ICC A117.1 Comments on 1st Draft

**Proposal list to the 2017 A117.1 for the 2023 edition –
9-12-2024**

Proposal list to the 2017 A117.1 for the 2023 edition – 1st draft comments

Overlap allowed for existing

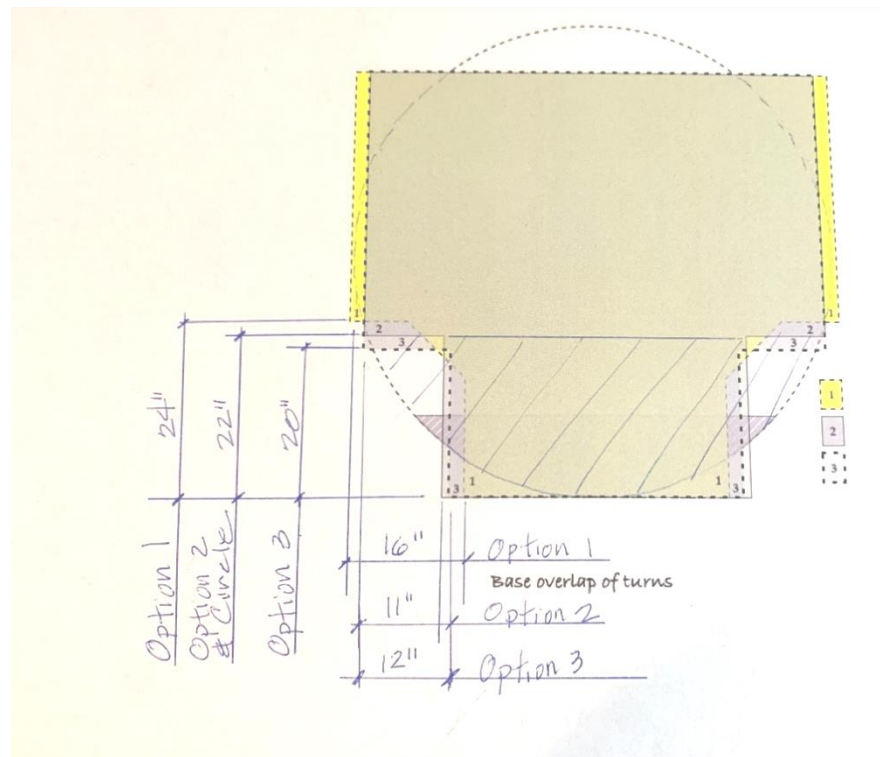
REASON: The purpose of this proposal is to coordinate the overlap allowances for turning spaces. The A117.1 decided not to change the knee and toe clearances between the 2009 and 2017 edition. The turning spaces have increased in size and substantially limited the overlap at the same time. Since the circle and T-turn are to turn 180 degrees, they should be consistent – while now there are substantial differences in all 4 options. With the larger turning space, these proposals will still be a reduction on the total percentage of the turning space permitted under the sink, counter or drinking fountain. With the current text people just play games with the options to get the best for that design – thus making it much harder to verify compliance. Below are proportional comparisons of the existing and new construction requirements.

1. The depth of the overlap shall not be more than ~~40~~ 22 inches (~~255~~ 560 mm), and
2. The depth shall not exceed the depth of the knee and toe clearances provided, and
3. The overlap shall be permitted only within the turning circle area shown shaded in Figure 304.3.1.

FIGURE 307.2
LIMITS OF PROTRUDING OBJECTS

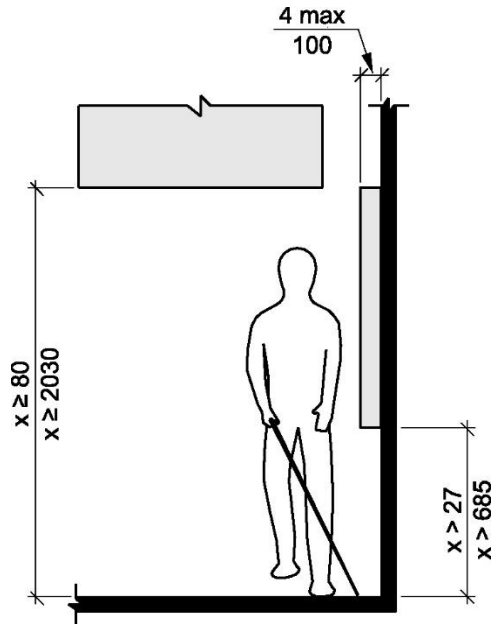
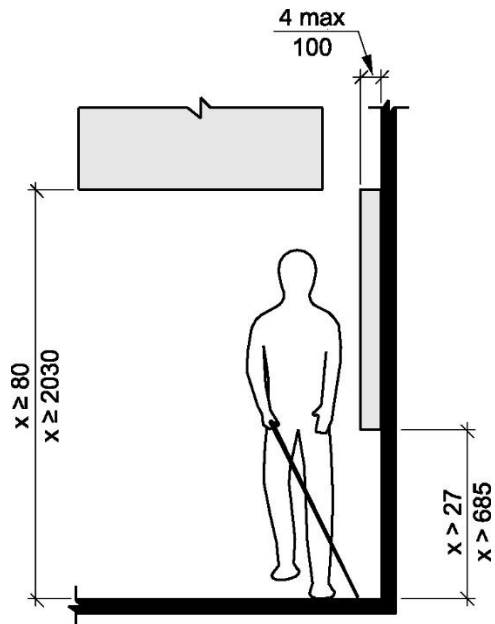
REASON: A typo and grammatical error in the original proposal were corrected and language added to clarify that this exception does not allow fixtures, countertops and equipment to be hazardous to someone walking in parallel direction. The last sentence clarifies where the leading edge should be measured.

Exception: Overhanging fixtures, countertops and equipment shall not be considered protruding objects where a leading edge does not protrude more than four inches horizontally into a circulation path perpendicular to the direction of the front approach.

Figure 307.3 (B)

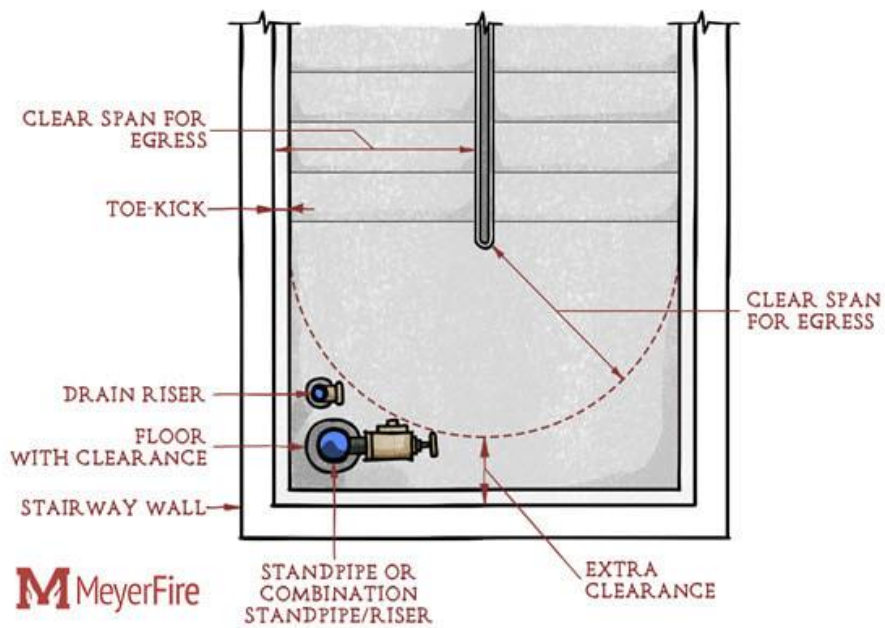
There is a current issue with standpipes where required in exit stairways. Fire department have to have access to connections, including substantial room for leverage to operate valves. Where designers have chosen cowl detection, access is limited. Where designers have chosen low bars for detection, some code officials have cited them for reducing the landing to below the required depth. **ADA allows for objects on posts to stick out 12” maximum.**

POST-MOUNTED PROTRUDING OBJECTS

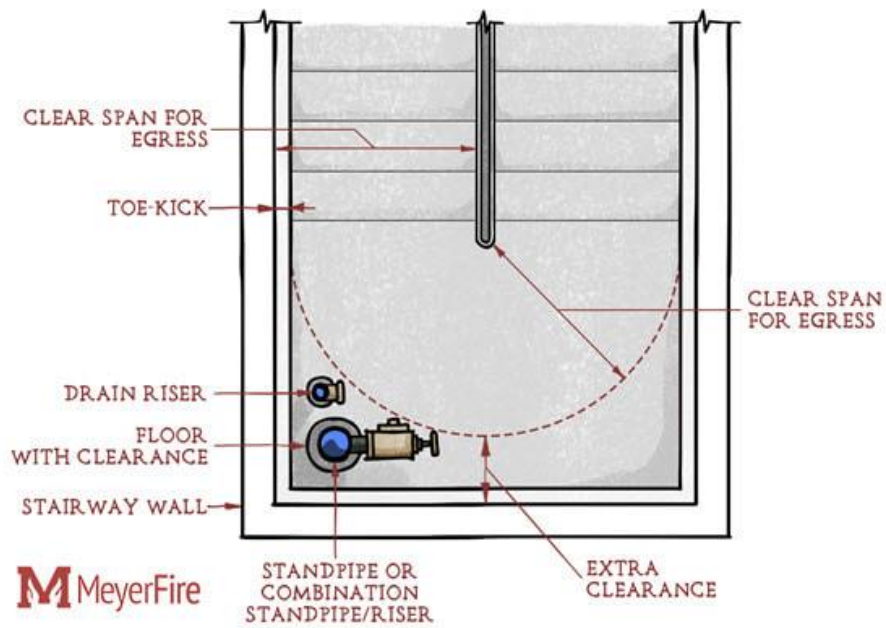
Reason: There is a current issue with standpipes where required in exit stairways. Fire department have to have access to connections, including substantial room for leverage to operate valves. Where designers have chosen cowl detection, access is limited. Where designers have chosen low bars for detection, some code officials have cited them for reducing the landing to below the required depth. **ADA allows for objects on posts to stick out 12" maximum.**

Example bathroom layout with 90 degree and U-turns.

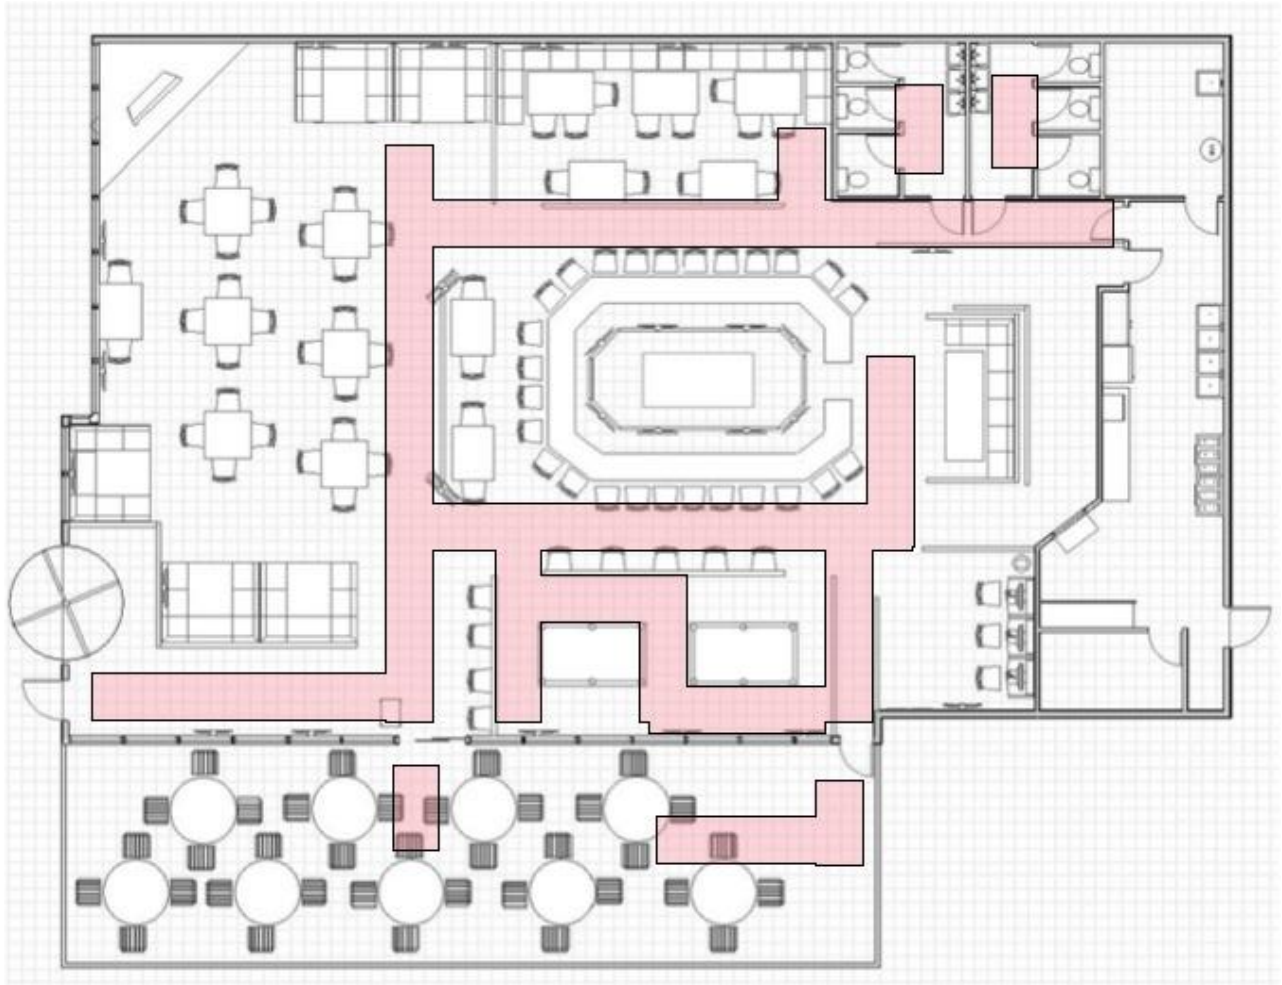
you assume a turn, such as turning under a drinking fountain, dining surface, work surface or sink are not applicable because they are 'adjoining' an accessible route – not part of it! The requirements for 90 degree turns would not be technical work with alcove provisions or turning into a wheelchair space in assembly seating or into a ! Attached are a couple of general layouts showing where this is applicable.

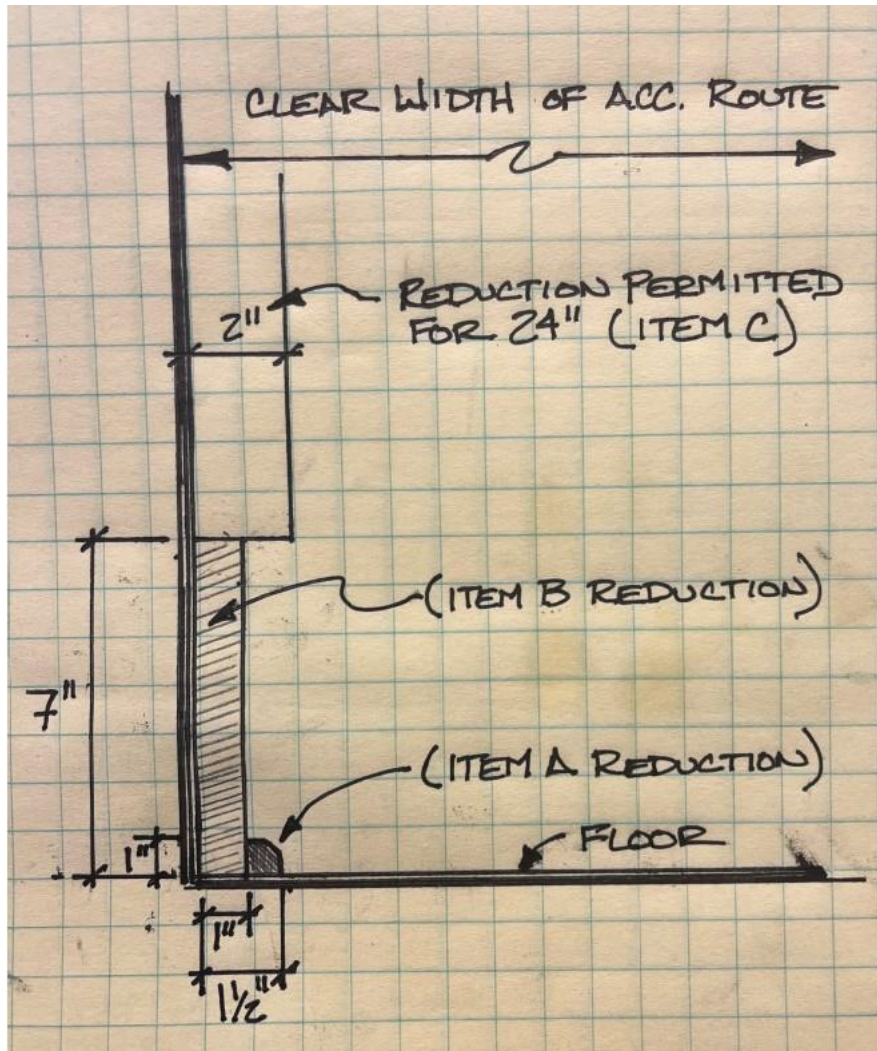
5. As pointed out in item 4 above there is a problem with the current draft not addressing existing exterior routes. I have added a new exception 5 which helps address the concerns of existing exterior routes which were built to the 36-inch width and are not being altered. This helps address some of the problems pointed out in comment 4 above and addresses the part of the intent of proposal 04-05 so that the existing exterior routes can remain in compliance and not require an alteration simply due to the specified width of the route being increased to 48 inches.

The standard should specifically permit existing exterior routes, which are not being altered, to remain at the previously permitted 36-inch width. As the draft is currently written, all exterior accessible routes would be expected to be 48 inches in width, which would force all previously compliant 36-inch routes to be increased – regardless of the fact that there were no modifications being made and possibly regardless of whether that is possible (since we don't have any of the text similar to the federal requirements about "unless technically infeasible").

FIGURE 406.2(A)
PERPENDICULAR CURB RAMP

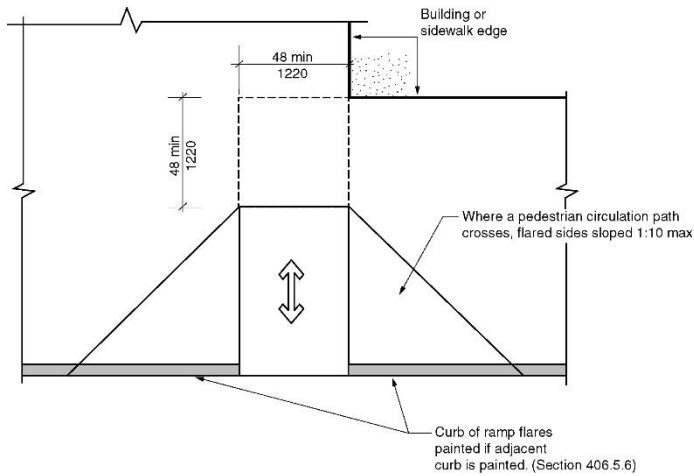
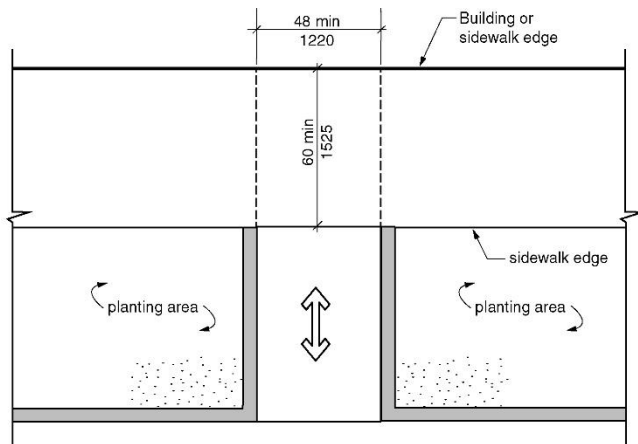
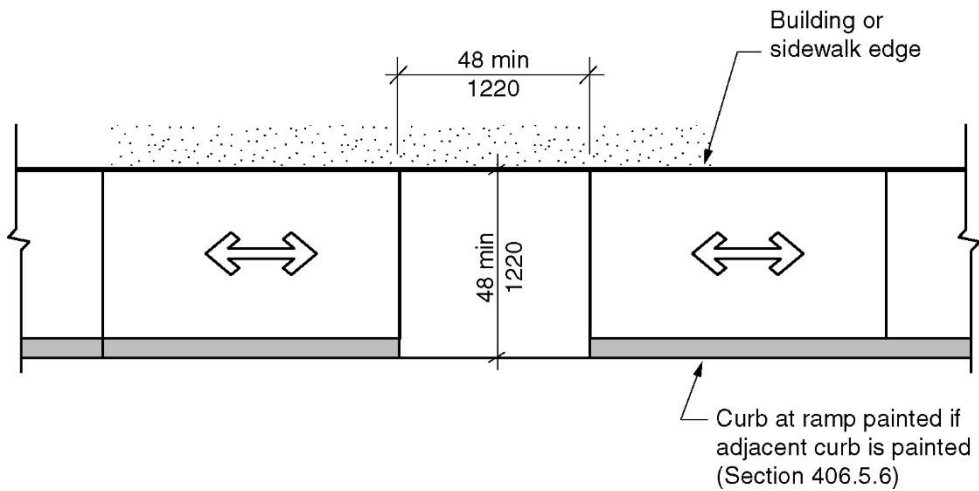
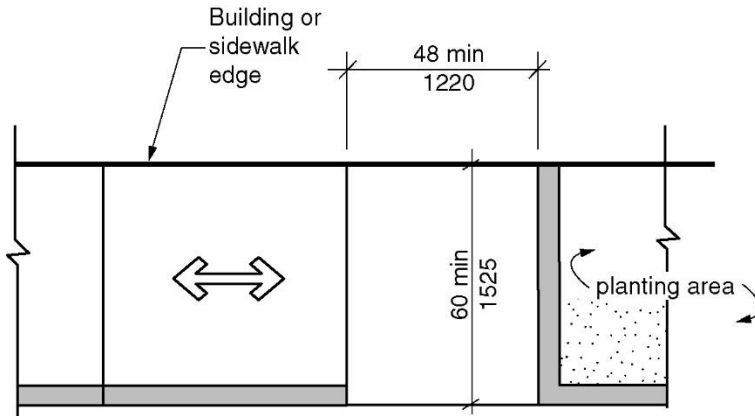
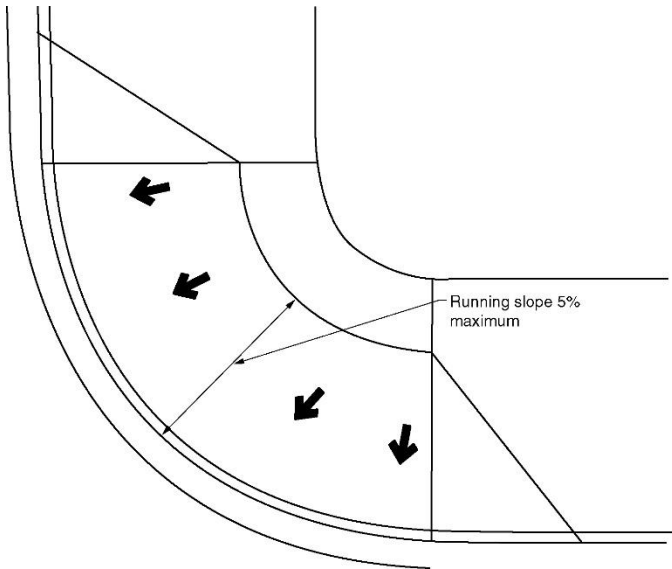
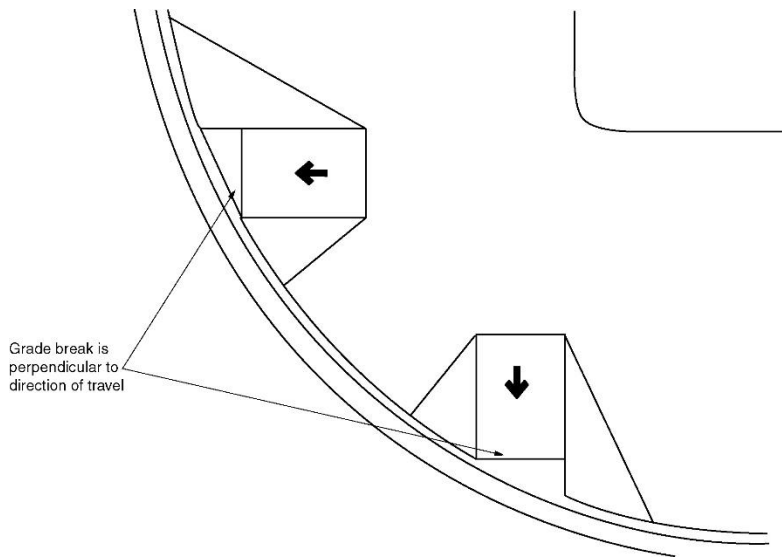
REASON: Curb ramps are not complete without detectable warnings. While there is a section showing detectable warnings on curb ramps in some detail, they should not be omitted here. It implies that they are not required. Wherever curb ramps are depicted, unless they are not required to have detectable warnings, as in Figure 502.9.1, the detectable warning should be included. Figure 502.9.1.2 correctly includes the detectable warning, even though it is in Section 502 Parking Spaces.

Committee Reason: The first modification was approved because the committee felt that it was important to clarify that detectable warnings were only required in limited situations, thus the addition of the note in each drawing. The 2nd modification was approved to remove the original proposal’s suggestion to show the detectable warning on each curb cut. The committee felt that many people just looked at the pictures rather than the text, so showing the detectable warnings would be misleading. The final proposal was approved because the committee felt the note would address the concern for where detectable warnings would be required and at the same time not seem to require detectable warnings at all locations – especially at locations where detectable warnings would provide misinformation – like at access aisles or into parking lots. PROWAG requires detectable warnings at street crossings.

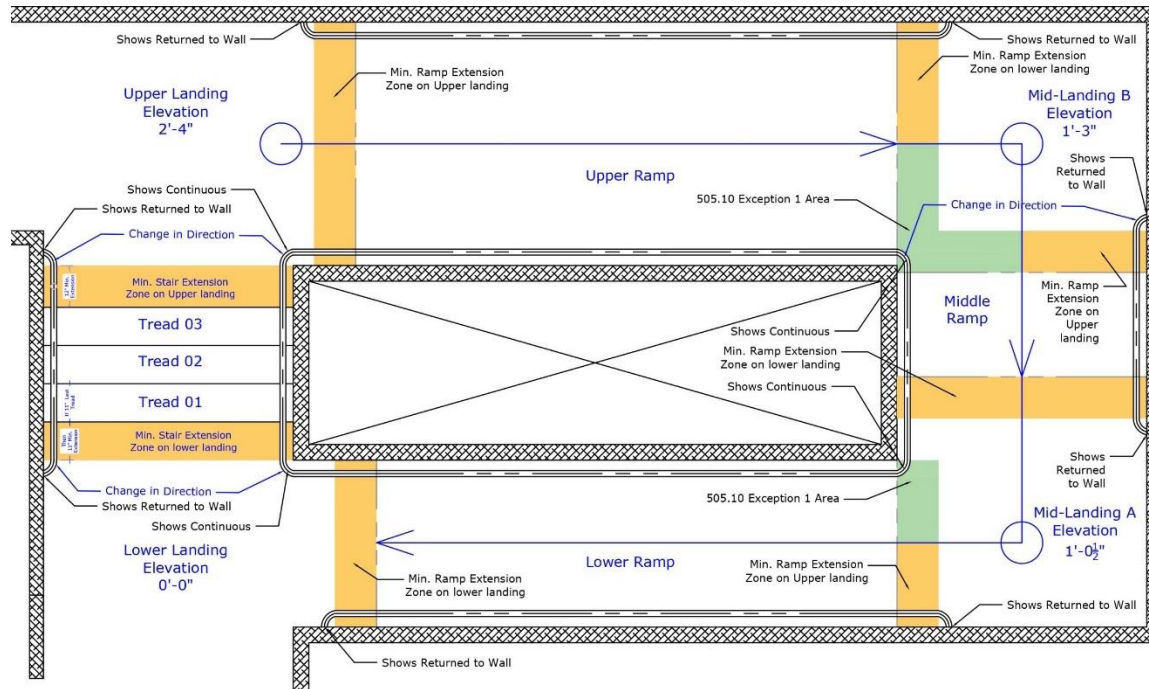
In the last sentence in 505.10.2, which only allows the handrail extension at the top of a stair flight to connect and be continuous to another stair flight handrail, or it must return to a wall, guard, or landing surface. It clearly defines no option to be continuous to a handrail of a ramp, even after exceeding the minimum extension requirements for both the ramp and stair.
